World Forum for Harmonization of Vehicle Regulations (WP.29)

Working Party on Passive Safety (GRSP)  
(Thirty-third session, 2 - 6 June 2003,  
agenda item B 1.6.)

PROPOSAL FOR DRAFT AMENDMENTS TO REGULATION No. 44

(Child restraints)

Figure 1  
Arrangement for testing a forward-facing device"

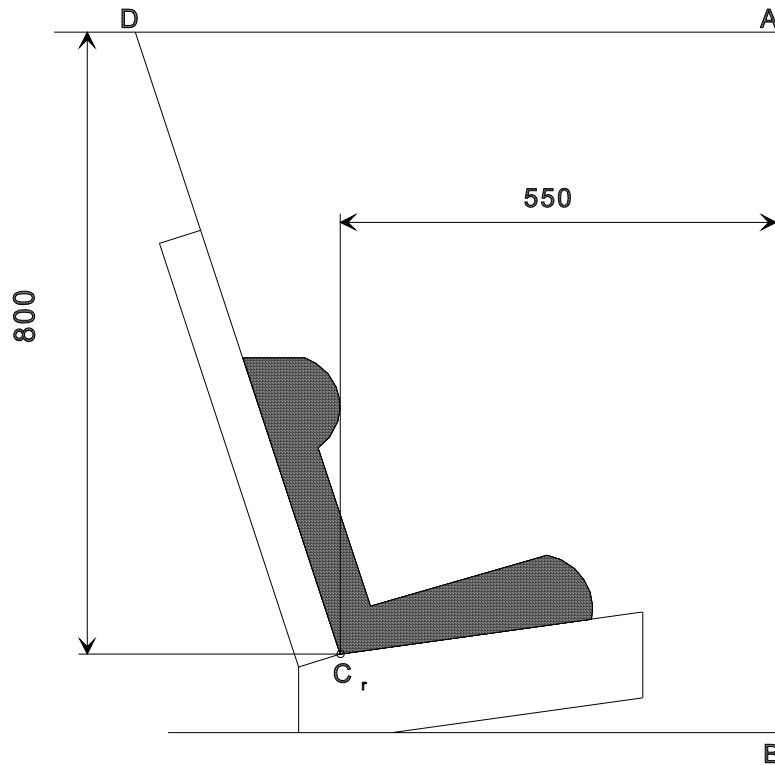
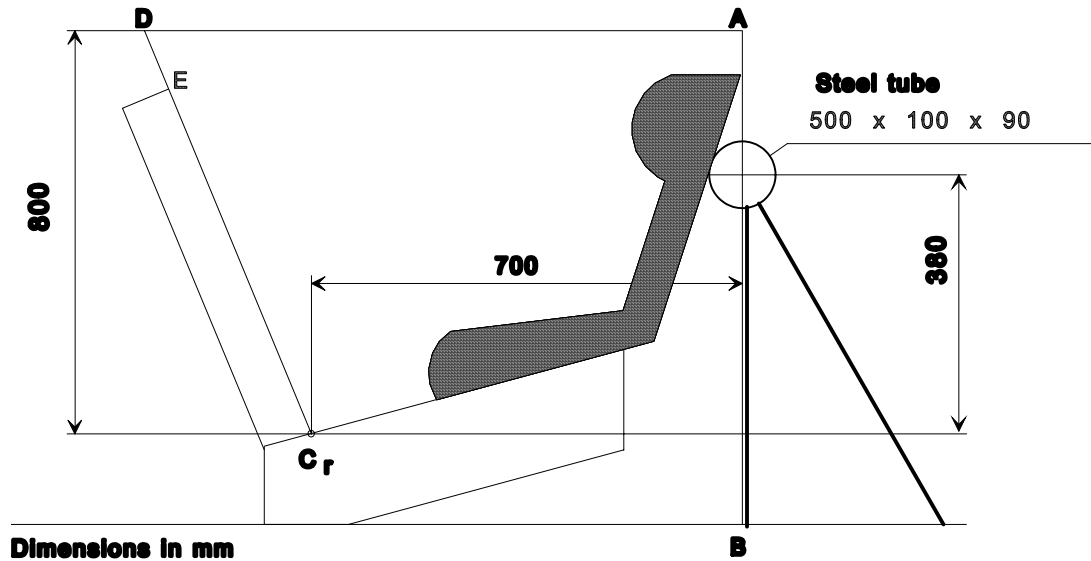
Paragraph 7.1.4.4.1.1., amend to read

"7.1.4.4.1.1. Forward facing child restraints: the head of the manikin shall not pass beyond the planes BA and DA as defined in Figure 1 below. This shall be judged up to 300 ms or the moment that the manikin has come to a definitive standstill whatever occurs first.

Figure 3

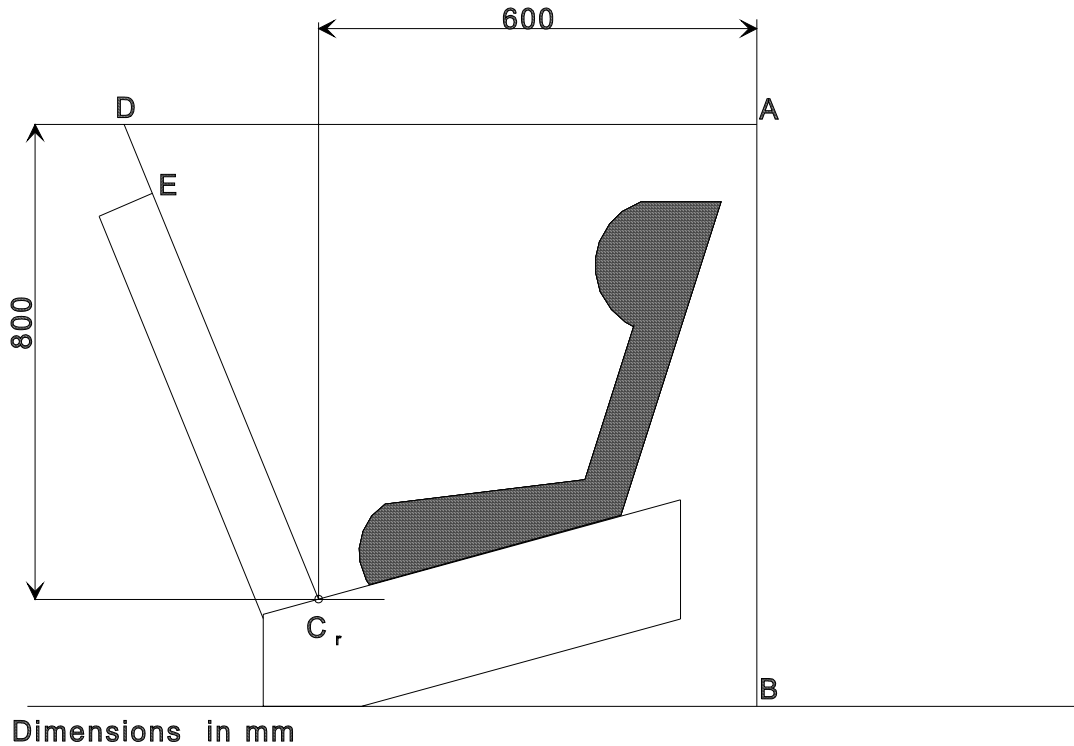
Paragraph 7.1.4.4.1.2.2., amend to read:

"7.1.4.4.1.2.2. Child restraints in group 0 not supported by the dashboard, and carrycots: the head of the manikin shall not pass the planes AB, AD and DE as shown in Figure 3 below. This shall be judged up to 300 ms or the moment that the manikin has come to a definitive standstill whatever occurs first.
